Planning
Assessment
Commission

Dubbo Zirconia Project

Review Report

February 2015

Figure 3: Proposed transport route

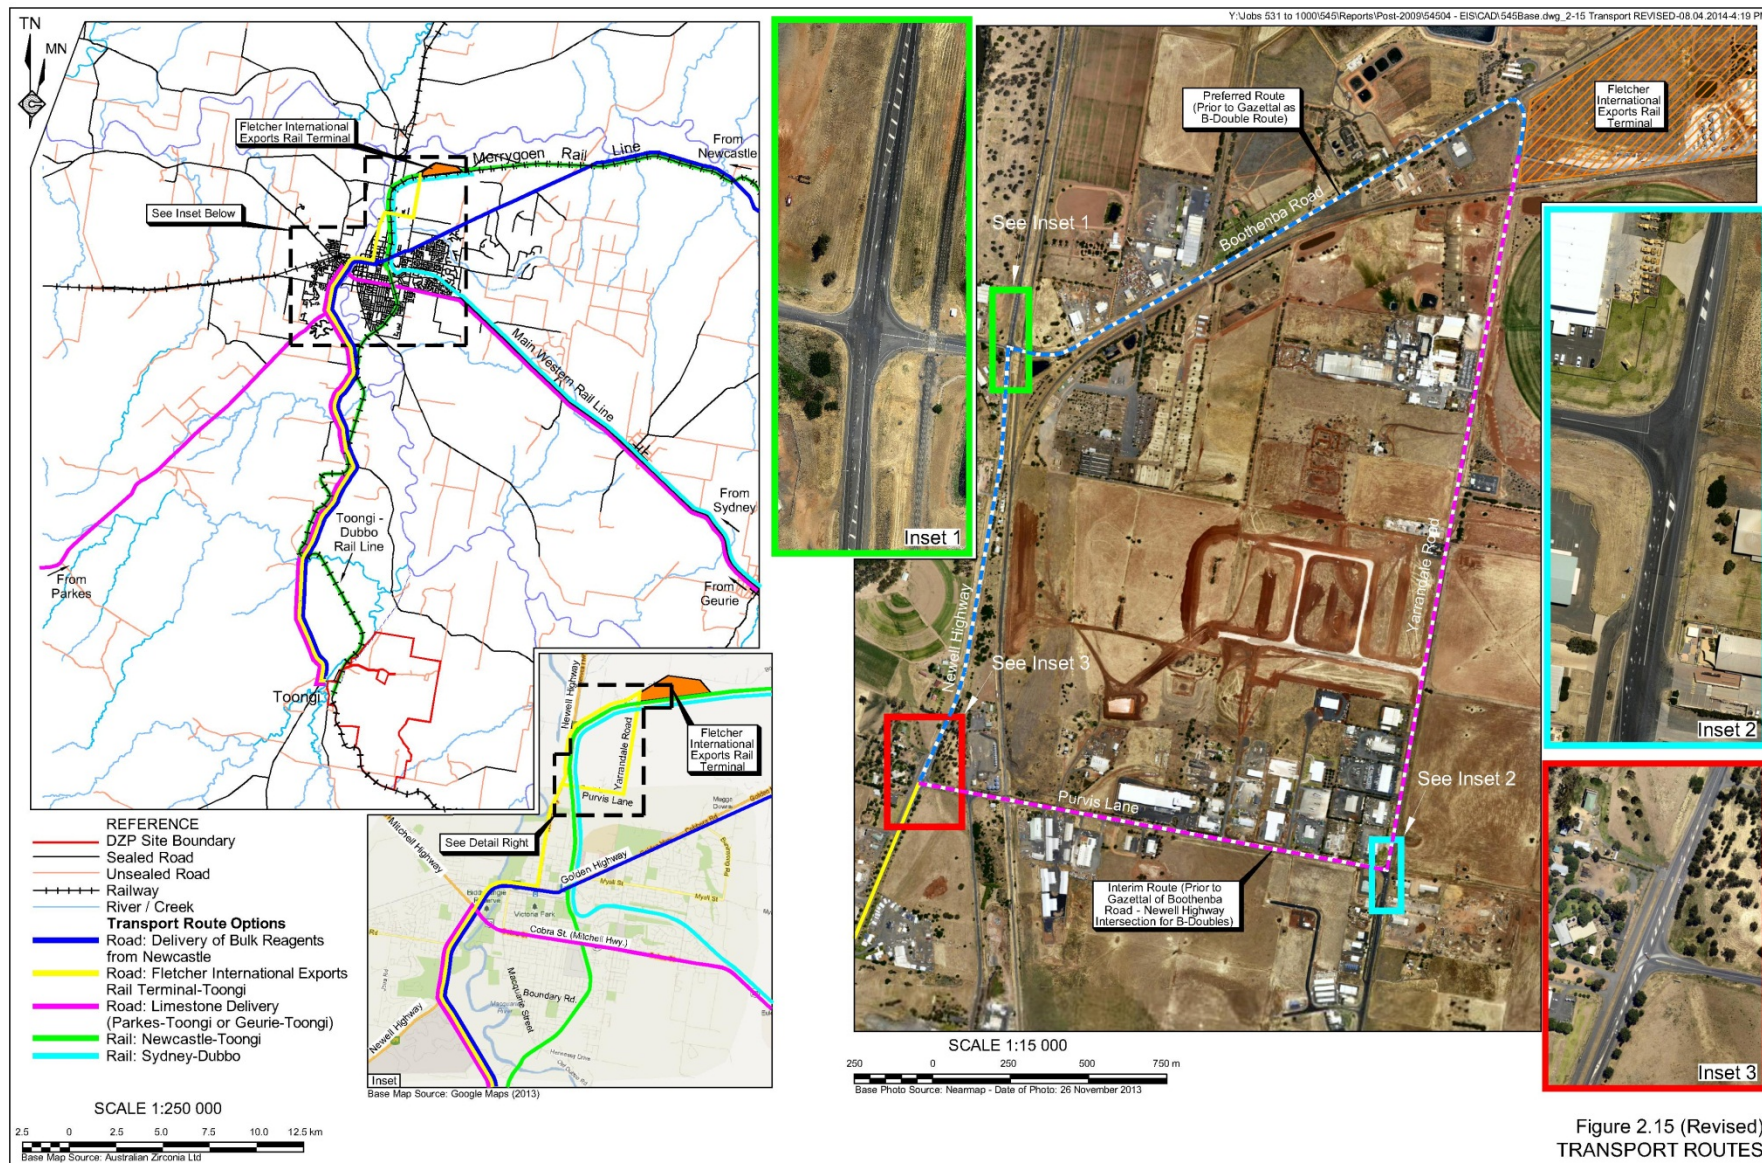
12. AZL be required to limit rail traffic movements to the day / evening period (outside of night time period) and heavy vehicle movements to daytime hours.

Figure 4: Conceptual Final Landform (Source: RW Corkery & Co. 2013a)

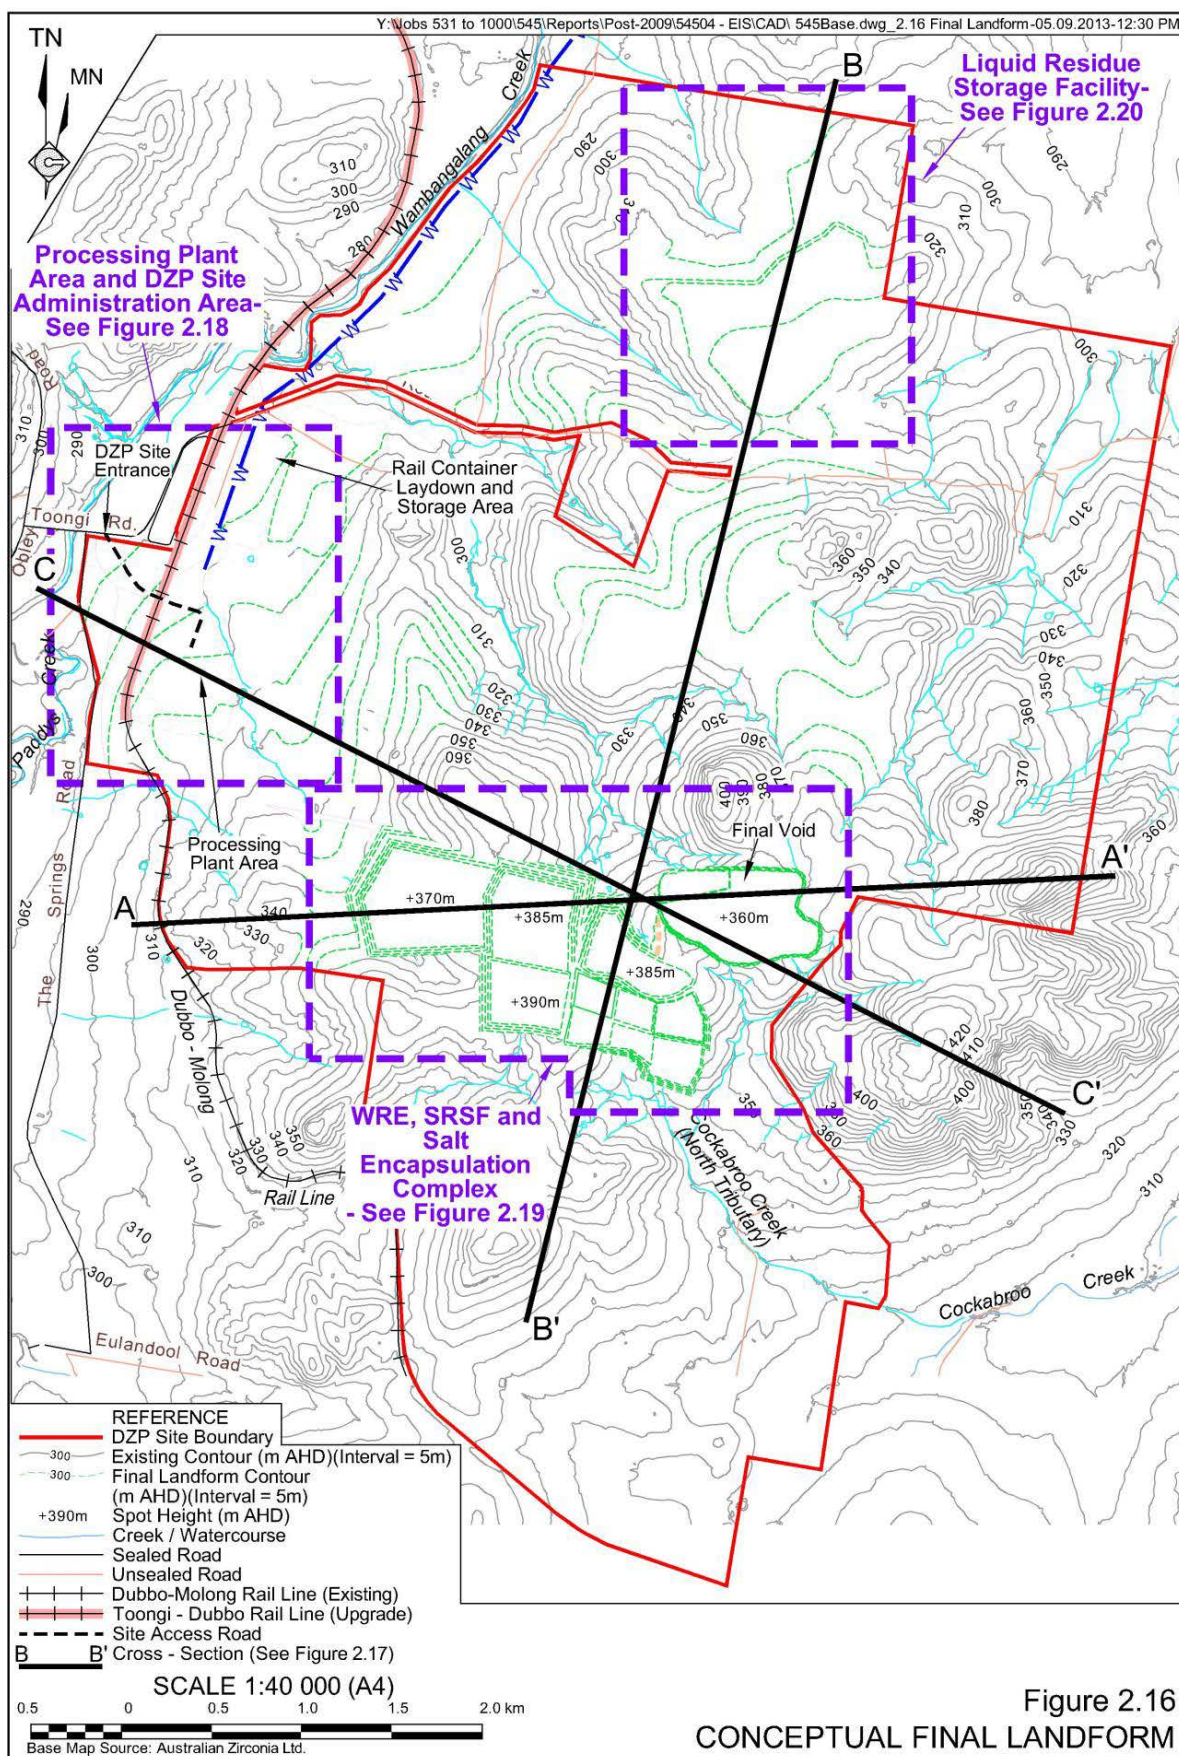
However, the Commission notes that DRE has raised concerns regarding the intention that the final land use be identified at a later time and the identification of potential land uses which are not consistent with the existing land use strategies in the region (notably identification of future industrial use and possibly rural residential). DRE has recommended a condition of approval requiring the preparation of a final land use plan consistent with existing surrounding land uses and zonings.

Figure 4 above (p24) illustrates the proposed final landform post mining operations on site.

13. Conditions of consent should limit the final land uses of the site to agriculture and biodiversity conservation and an amended land use plan reflecting this requirement should be required prior to commencement of construction on the site.

Figure 6: Indicative Final Land Use (Source: RW Corkery & Co. 2013a)

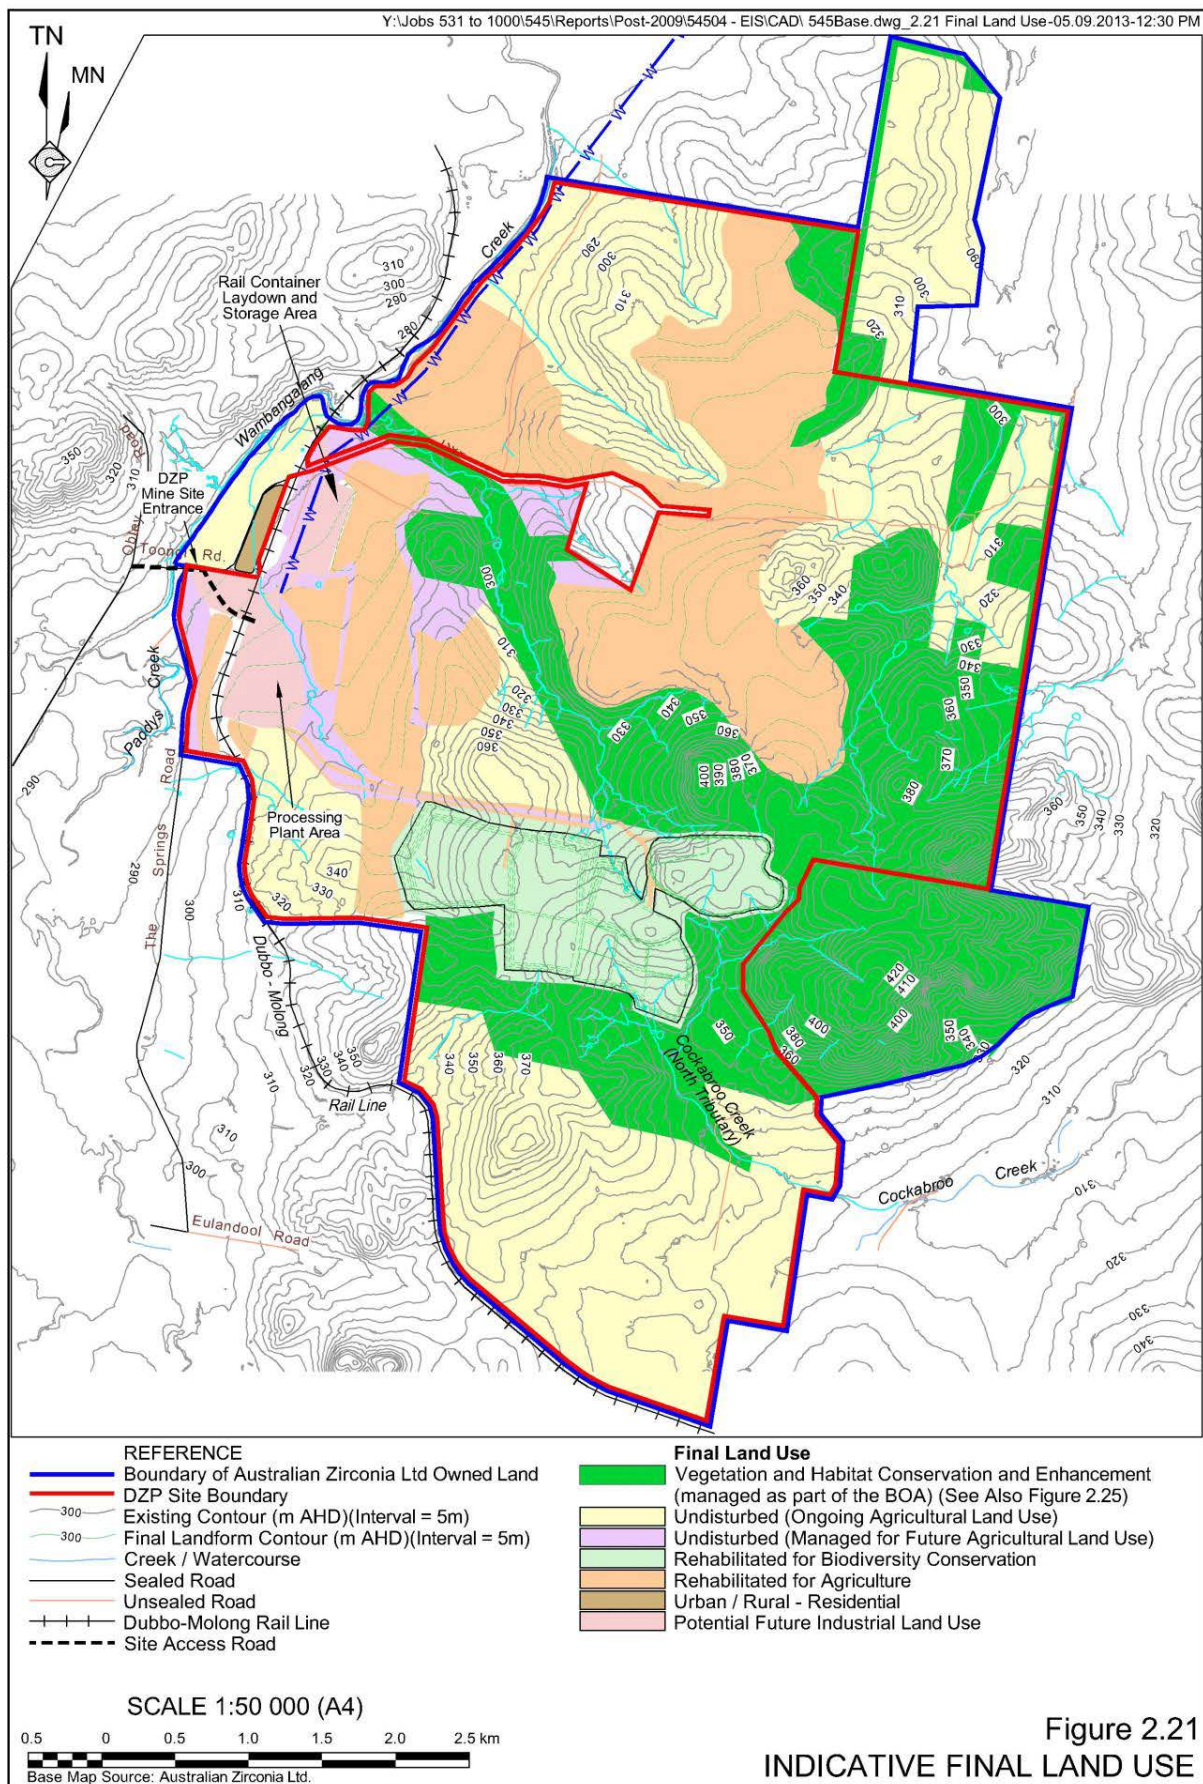
The proposal indicates that the landform is ultimately dependent on the intended final land use and could be modified during the life of the Proposal. It proposes that the final land use be determined with the community and relevant government agencies prior to decommissioning of the project however the Commission notes that an indicative final land use is included as illustrated in Figure 6 below. The Department's report has indicated that this approach is appropriate.

The Commission agrees with DRE and considers that any future use of the administration area for industrial or other purposes should be subject to Council's strategic planning process including not
